LAND USE APPLICATION - COMPLETENESS REVIEW

Subject Property:	5660 Commercial Street SE
Reference Number:	24-115890
Application Type:	Class 2 Site Plan Review
Date Application Accepted:	July 26, 2024
Applicant:	Marcus Lima marcusl@gbdarchitects.com
Contact:	Same as applicant

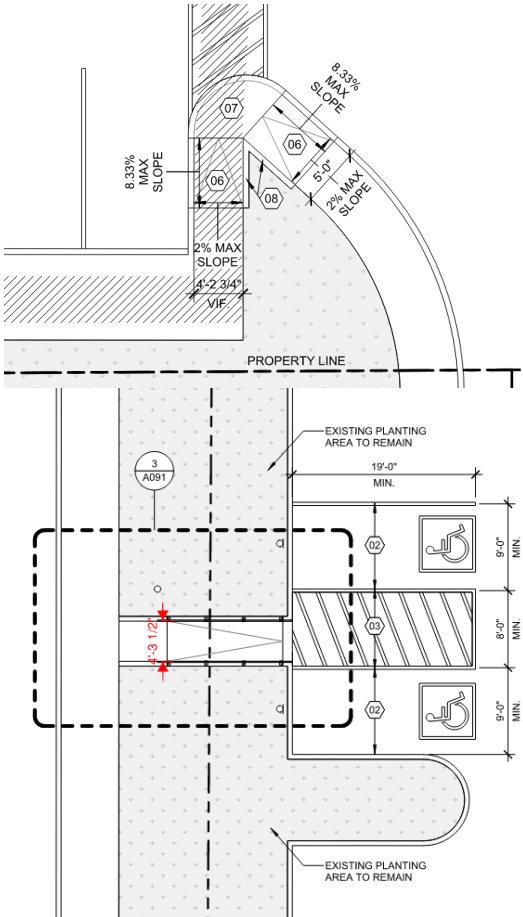
800.065(b)(1)(A) Width of Pedestrian Paths	<p>All areas altered need to meet required five-foot width for pedestrian connections. The areas shown below does not meet the five-foot width.</p>  <p>Please alter these to show the required 5 foot width.</p>	<p>The sections of pedestrian path that are proposed to be modified have been updated to show a 5'-0" minimum clear dimension. See revisions to enlarged plans 3/A090, 1/A091, and 3/A091.</p>
